**THE CITY OF KEY WEST
PLANNING BOARD**

Staff Report

Agenda Item: **Minor Development Plan, Conditional Use – 701 Palm Avenue (RE# 00001761-000000)** – A request for a minor development plan to construct a two-story commercial structure and a request for conditional use approval to allow for redevelopment of a marina with the construction of dry storage racks, located in the Public and Semipublic Services (PS) zoning district, pursuant to Section 108-91, Chapter 122, Article III and Article IV, Division 13 of the Land Development Regulations of the City of Key West, Florida.

Proposed Landscape Plan

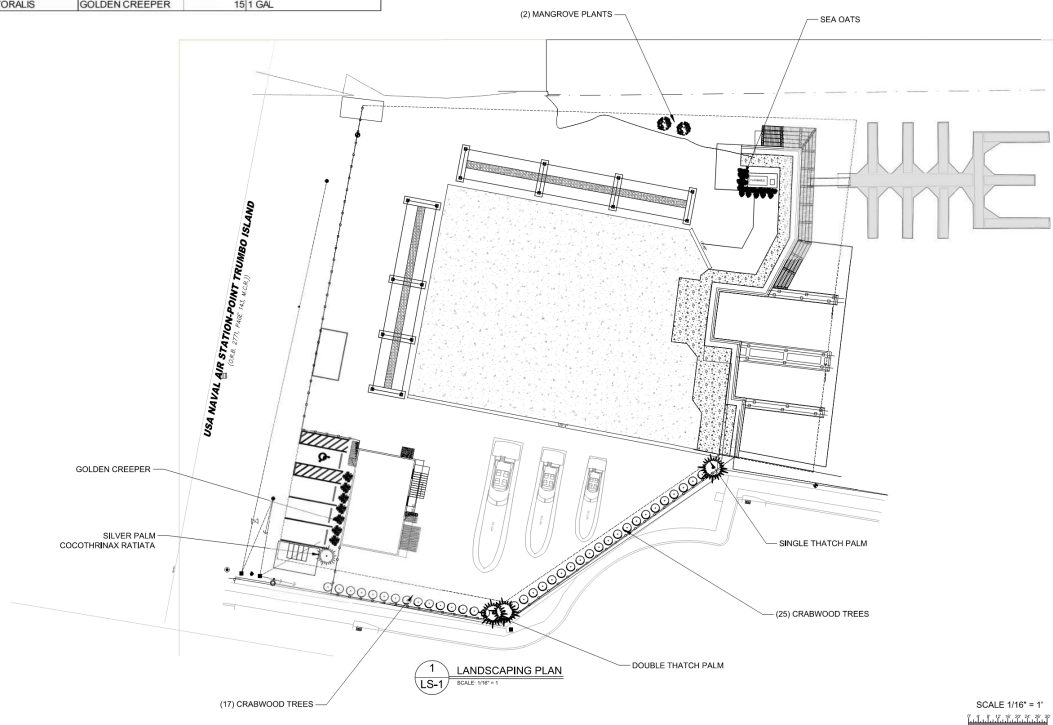
108-318. - Separation of vehicles, bicycles and pedestrians.		
Article V: Open Space, Screening & Buffers		
Sec. 108-346. - Open space, landscaping and removal of exotic vegetation.	The applicant proposes landscaping improvements along the southern lot line and a portion of the building perimeter where none exists currently and the proposed configuration still meets open space requirements, as most of the site is proposed to remain as gravel.	Yes.
Sec. 108-352. - Reducing landscape and/or bufferyard requirements.	A landscape waiver is required for the 30' required street frontage landscape buffer.	Waiver required.
Article VI: Landscaping		
Sec. 108-411. - Landscape plan approval.	The conceptual landscape plan will be reviewed and voted upon by the Tree Commission on September 16, 2025.	Pending as of the date this report was written.
Sec. 108-413. - Requirements along street frontage.	The site requires a landscape strip along the frontage at least 30' in width, with at least 120 plant units per 100 linear feet.	No. Waiver required.

Sec. 108-416. - Other landscape requirements for nonvehicular use areas.	The site requires 4 trees for every 2,000 sq. ft. of nonvehicular open space.	No. Waiver required.
Sec. 108-452. - Required sight distances for landscaping adjacent to public rights-of-way and points of access.	N/A	N/A
Sec. 108-481. - Specifications for plant materials.	If palms are used, they shall constitute no more than 25 percent of total tree requirements	Yes.
Sec. 108-517. - Waivers or modifications.	Per Section 108-517, the Planning Board may waive or modify the standards of Chapter 108 Article VI upon a finding that the modification meets the criteria outlined in Section 108-517. Staff has reviewed the application and found it consistent with these criteria.	Yes.
Article VII: Off-Street Parking and Loading		
Sec. 108-571	Per Section 108-571, parking shall be provided at the time any building or structure is erected, which triggers	Yes, site improvement.
